ADDENDUM # 1

RFQ 7575502

**TITLE: Interior Renovations RIAG Building 150 South Main Street,
Providence**

This Addendum forms a part of the Contract Documents and modifies the Drawings and Project Manual as hereinafter indicated.

1 PENTHOUSE FLOOR PLAN - LIGHTING
Scale: 1/8" = 1'-0"

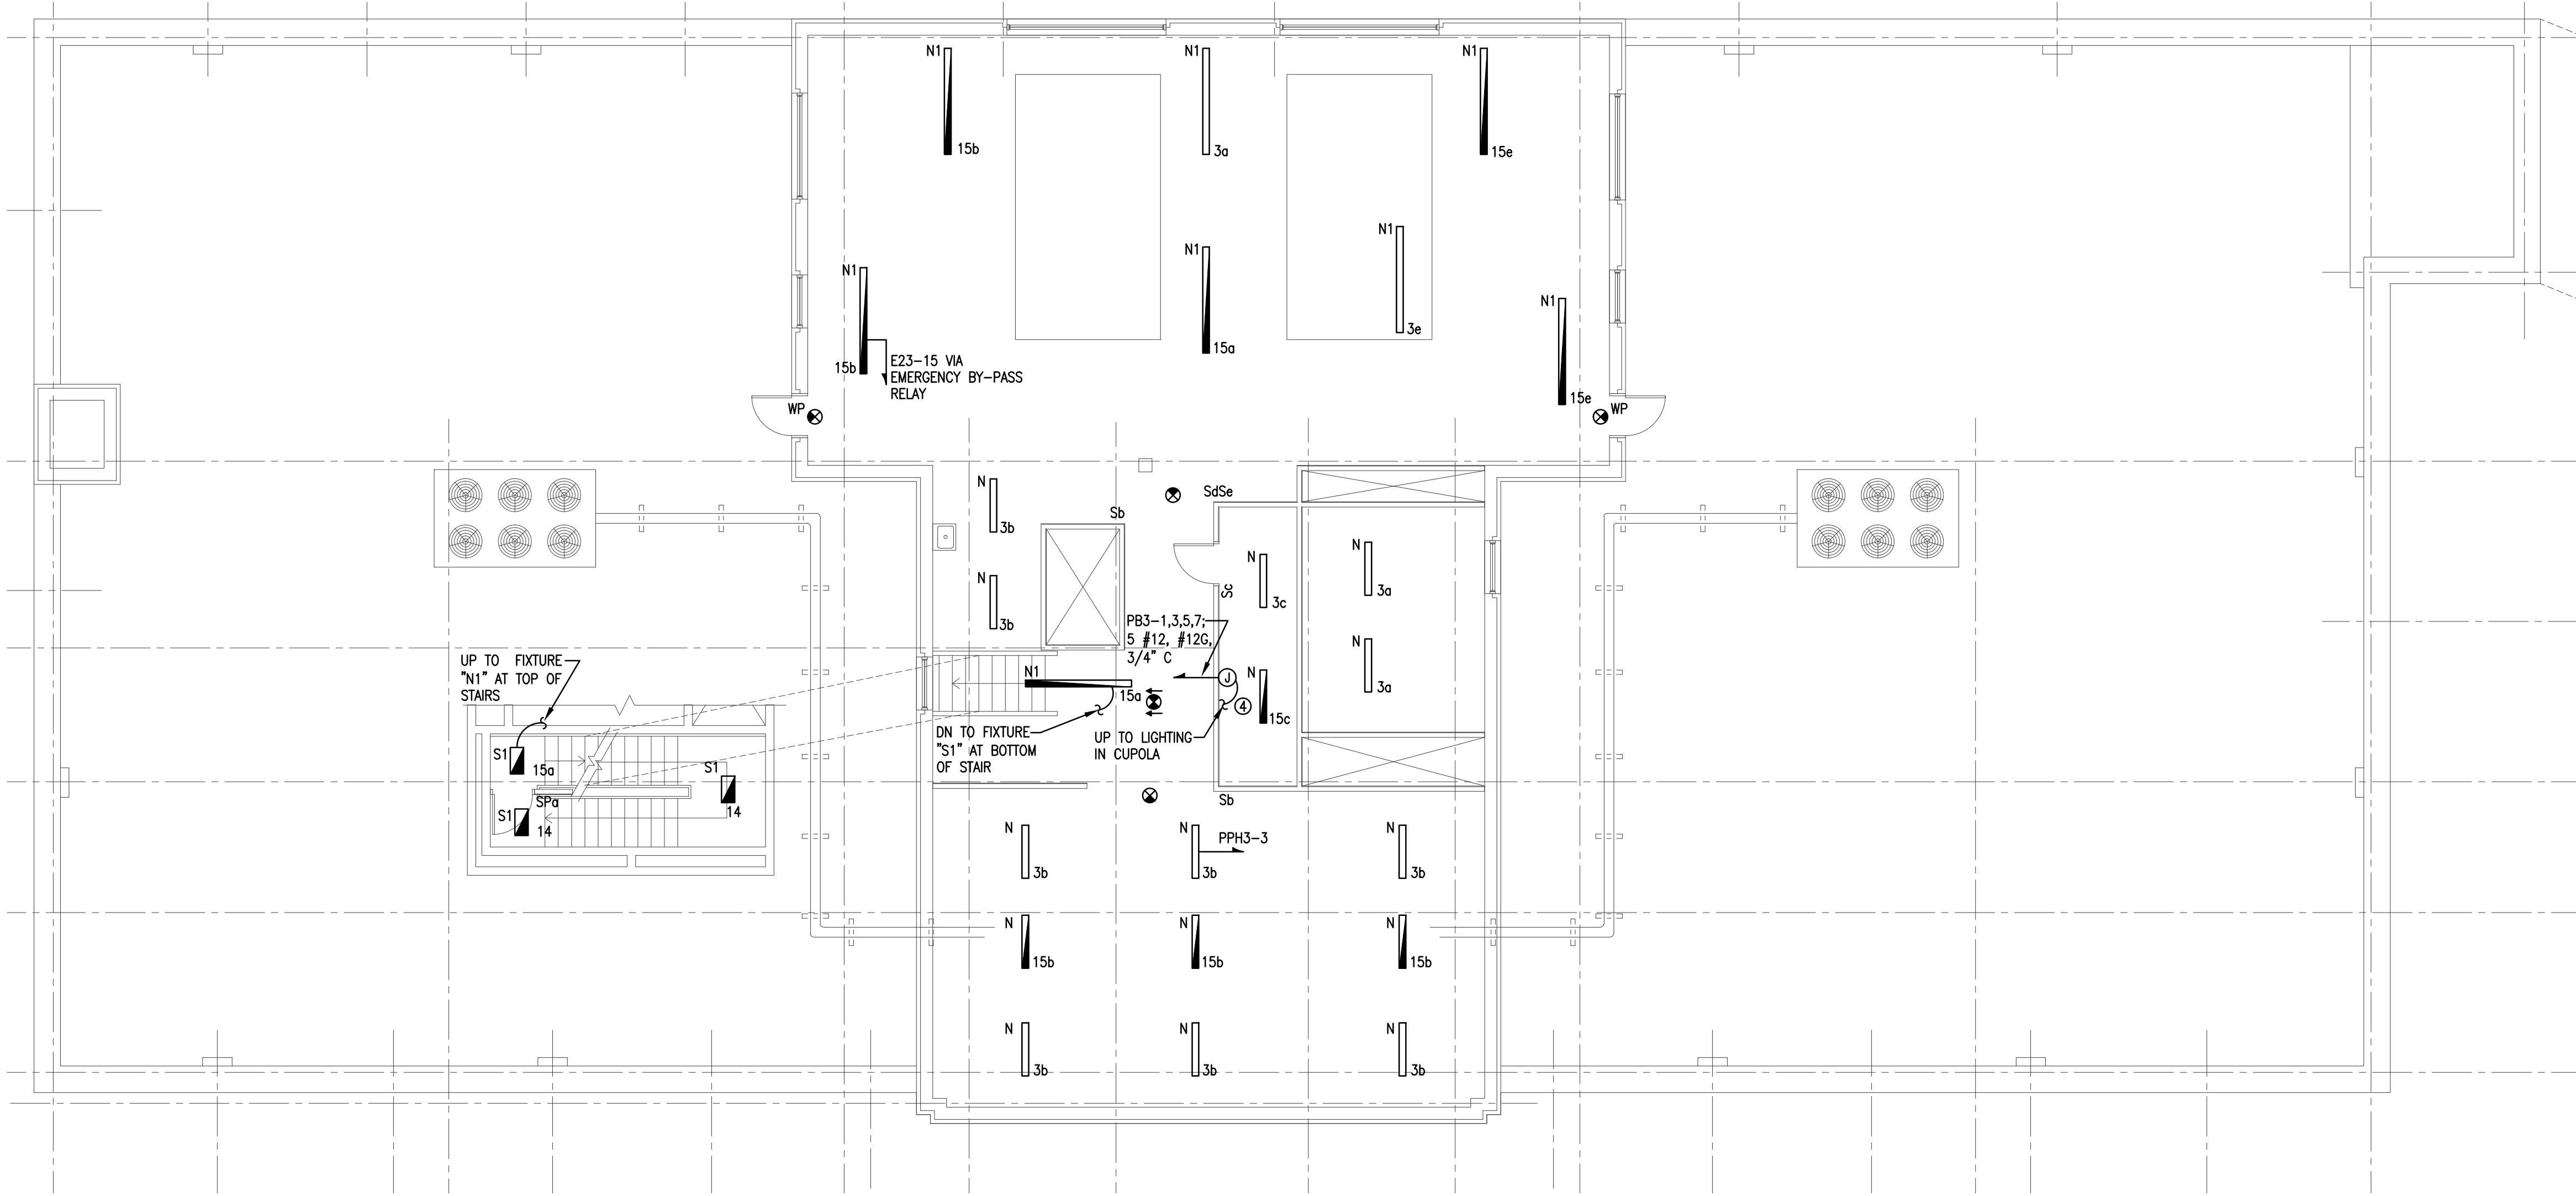
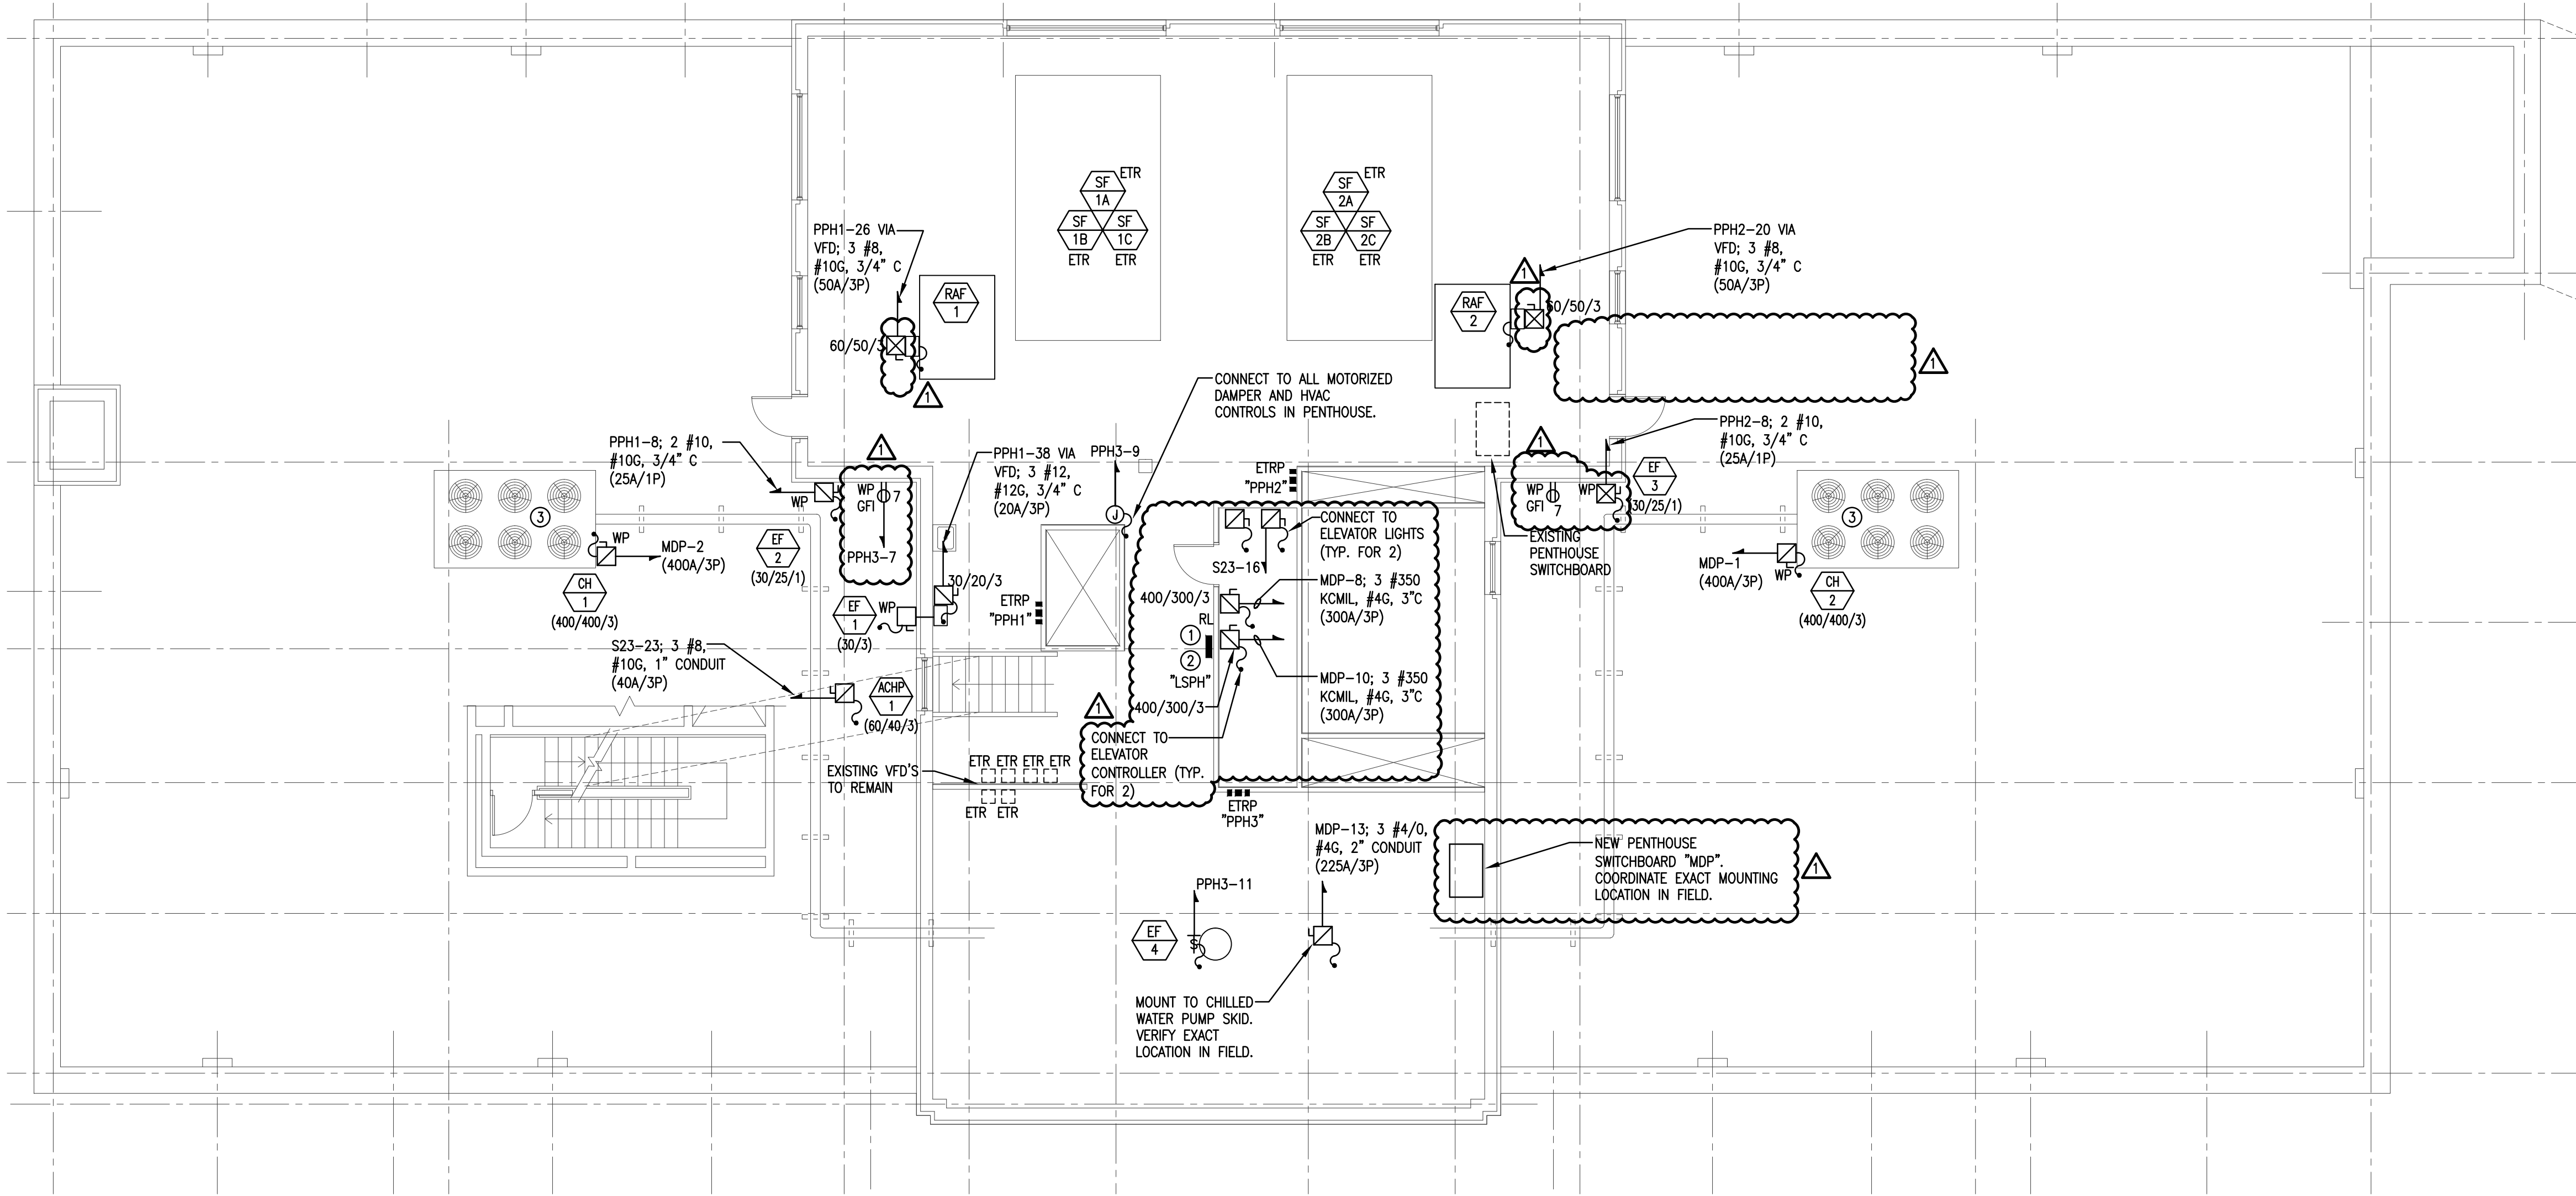
- B. Clarify toilet room flush valve power.
9. Drawing #E104:
 - A. Relocate new penthouse switchboard and revise rating.
 - B. Indicate individual feeders from penthouse switchboard to each elevator.

- C. Indicate standby power circuit to each elevator cab light circuit.
 - D. Added exterior service receptacles at roof mounted HVAC equipment.
10. Drawing #E200:
